Design Review Board Agenda

CITY OF MILL CREEK DESIGN REVIEW BOARD APPLICATION PL2018-0002

The Estates at Thomas Lake Freestanding Sign

The Estates at Thomas Lake HOA Sign Design plan

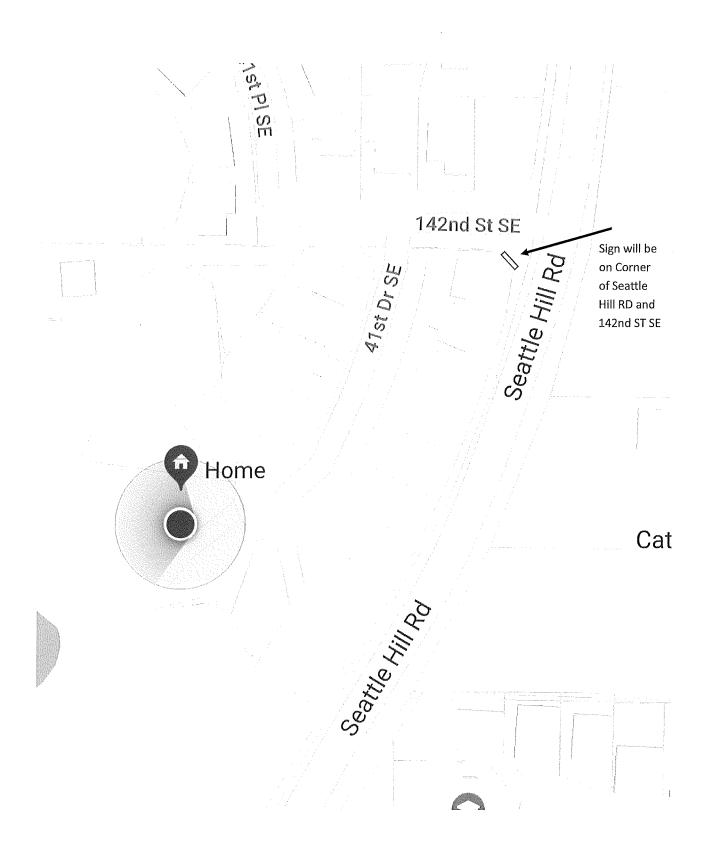
The applicant is proposing to install a metal sign on a wooden arbor on lot 1 facing Seattle Hill Road as shown on Attachment 2. The metal sign is proposed to be 60 inches wide and 32 inches in height and will be constructed of brushed aluminum. The text and logo will be cutout and the sign will be backed with a metal panel probably painted black, but the applicant is open to color suggestions from the Board. The metal sign will be attached to a wooden trellis that will be 72 inches in height and 72 inches wide as shown on Attachment 1. The proposed sign size is consistent with the dimensional requirements contained in the Code.

The brushed aluminum and wood of the sign supporting structure are complementary to and coordinate with the adjacent residences, in accordance with MCMC Section 17.34.040.G.3.

The sign will have only the name of the subdivision – The Estates at Thomas Lake, which is consistent with the Code.

- 1. The sign design, materials, and colors shall be as portrayed on the materials submitted with the application, except as may be modified by the conditions imposed by the Design Review Board.
- 2. The sign shall not be installed until a sign permit is issued by the Building Official.
- 3. The HOA shall consider adding a landscape element to enhance the subdivision entrance as well as the sign.

Attachment 2 – Location of Proposed Sign

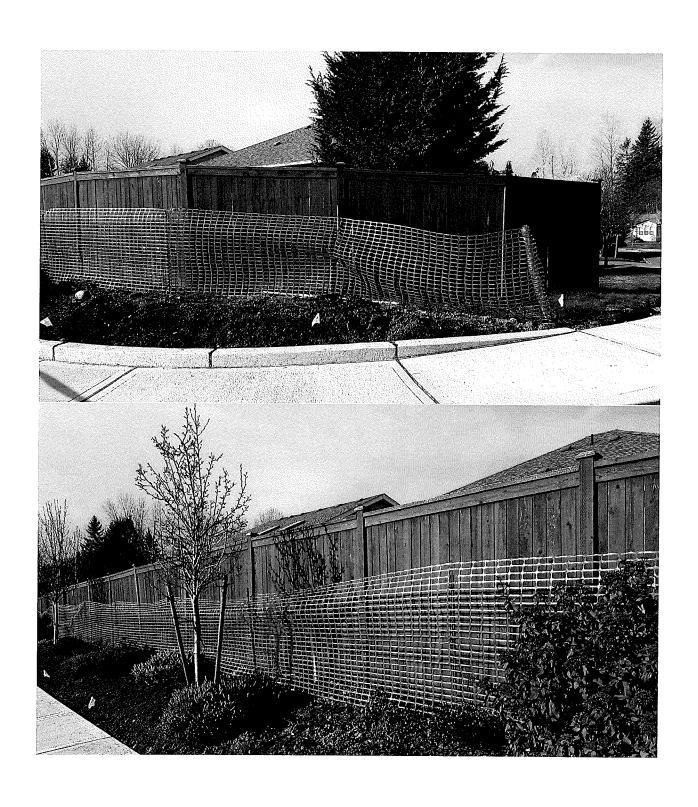
The freestanding sign is proposed to be located in an area that was disturbed by the County's recent Seattle Hill Road widening project. The plan is to locate the sign directly adjacent to the existing fence. There is minimal landscaping where the sign will be located, primarily lawn (see **Attachment 3** – **Existing Site Photos**). The Code does encourage landscaping with flowering trees or seasonal annuals to accent a subdivision entrance. Thus, staff is recommending as a Condition of Approval that the HOA consider adding a landscape element to enhance both the subdivision entrance and the sign.
